CITY OF ALBUQUERQUE

Resturant Remodel & Addition

10,000 Coors Blvd NW

30-Day Temporary Certificate of Occupancy Transportation Development Final Inspection

AMENDED SITE DEVELOPMENT
PLAN

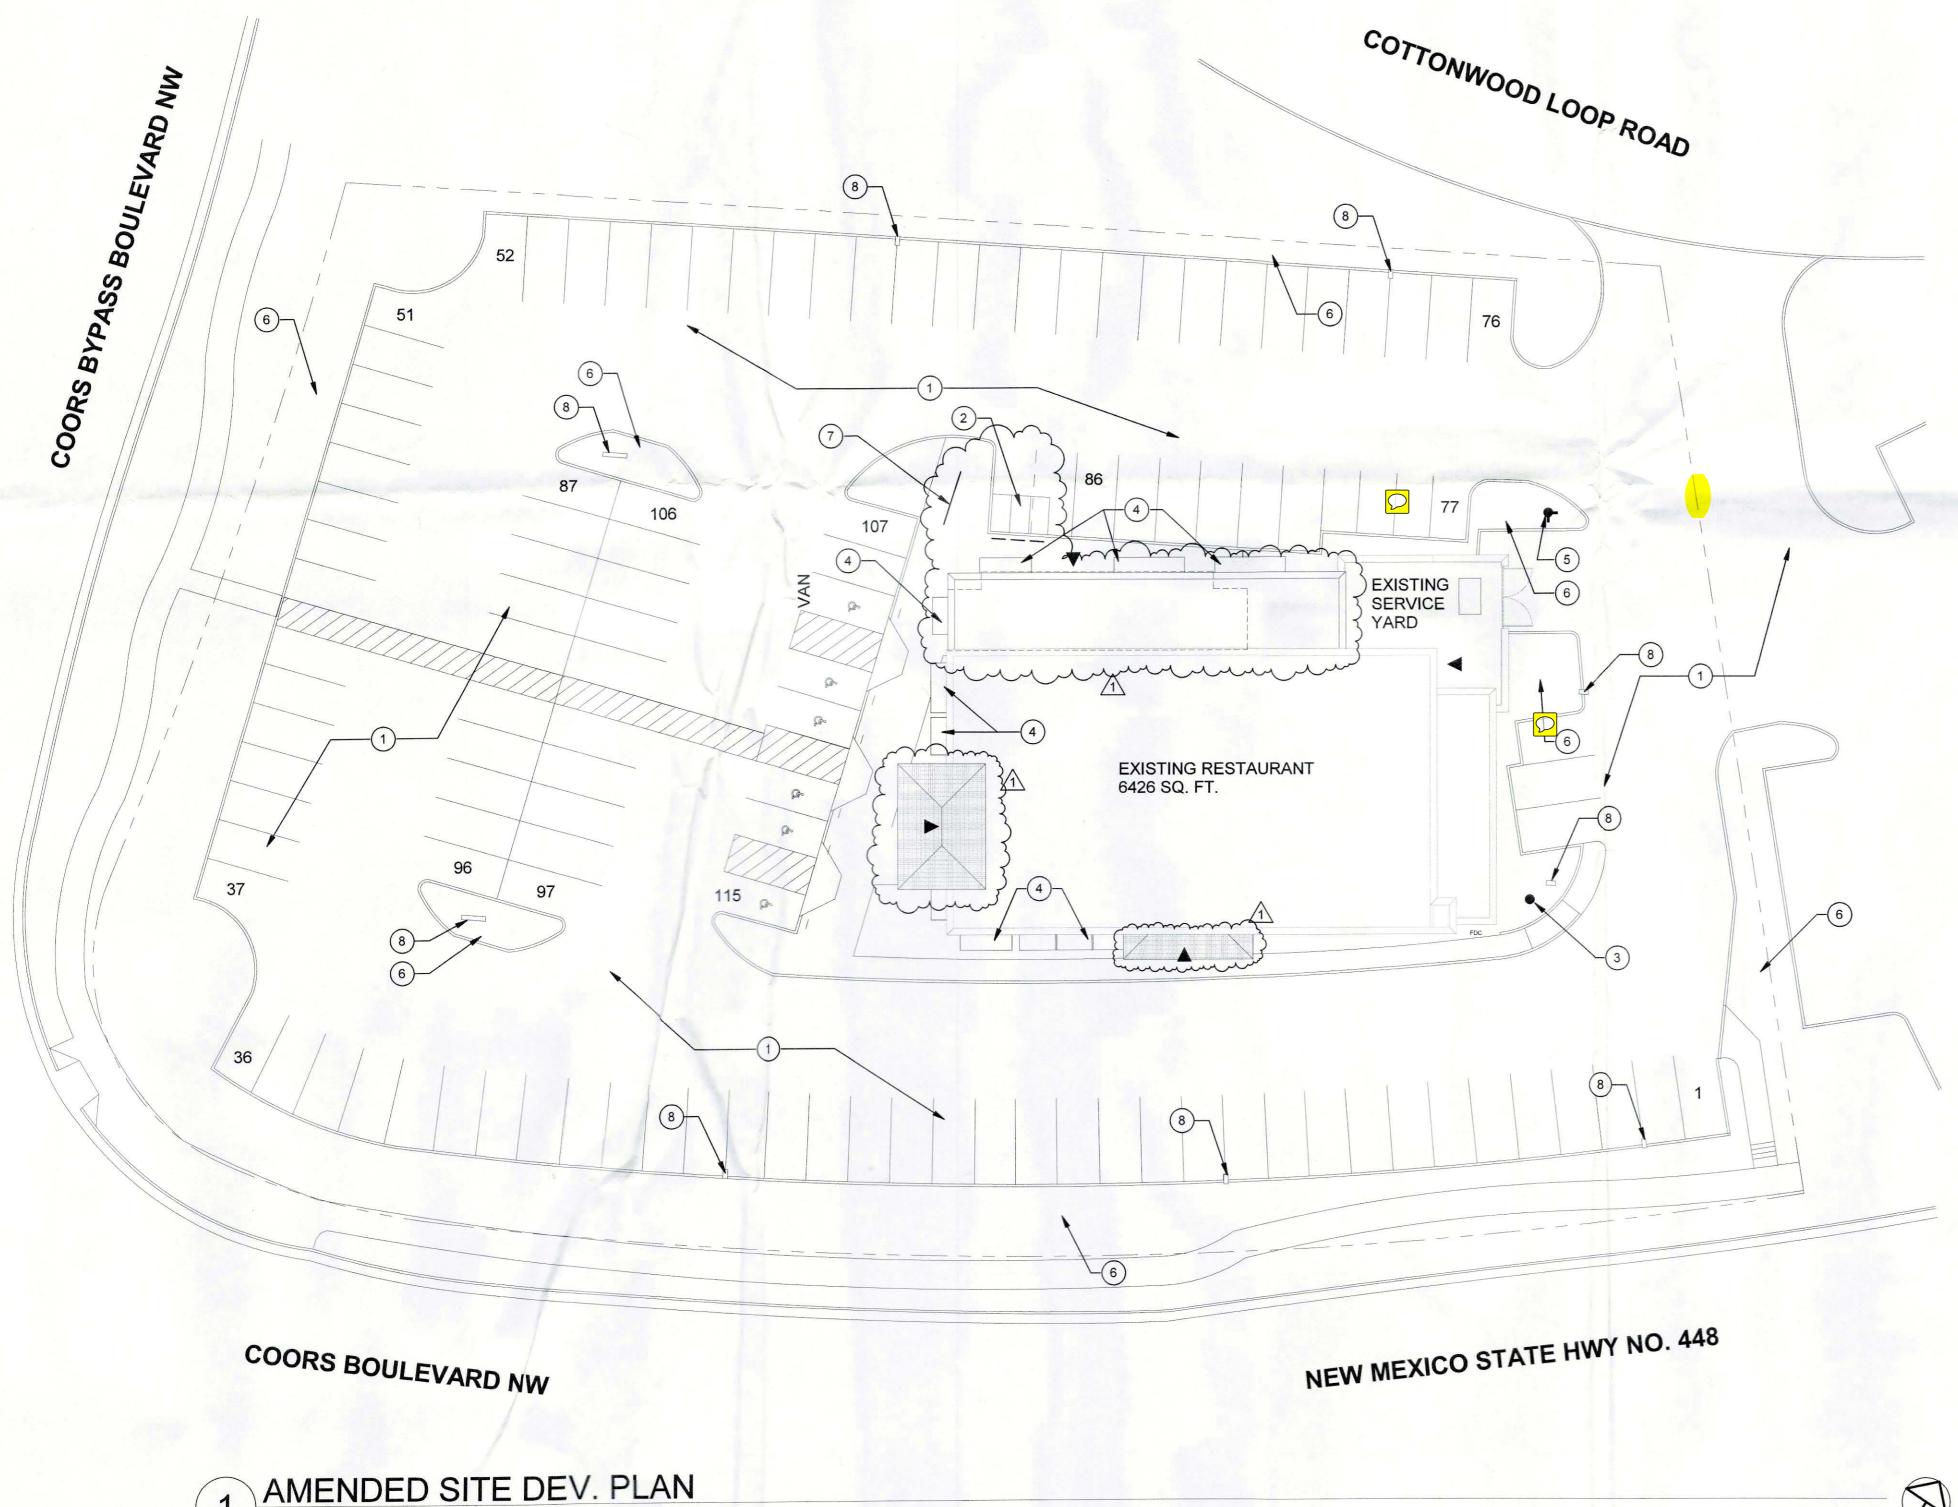
Please label the compact parking spaces by placing the words "COMPACT" on the pavement of each space. (5 Stalls measured 15 foot in length. See attached plan for locations)
